STEREO IMPACT SWEA LVPS

STEREO IMPACT SWEA LVPS REWORK INSTRUCTIONS

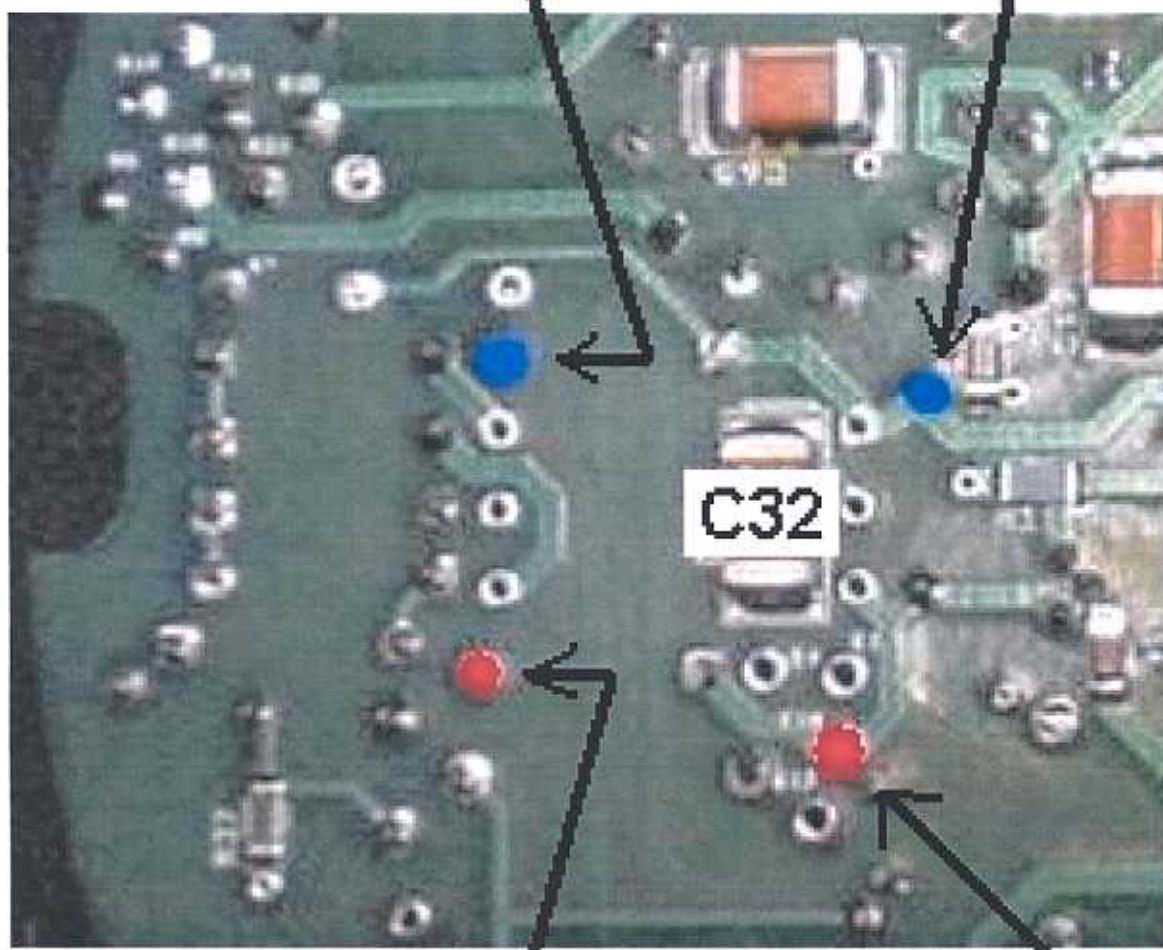
1. D30 and D32 must be moved to accommodate T4.

T4 is larger than its PWB outline, and extends into the locations for D30 and D32. The following modifications will accommodate the size of T4. (Note that T4 itself will not be installed until the appropriate point is reached in the LVPS Test Procedure.)

- 1) Remove D30 and D32. Install new diodes for D30 and D32 on the bottom side of the board, as indicated in the photograph below.
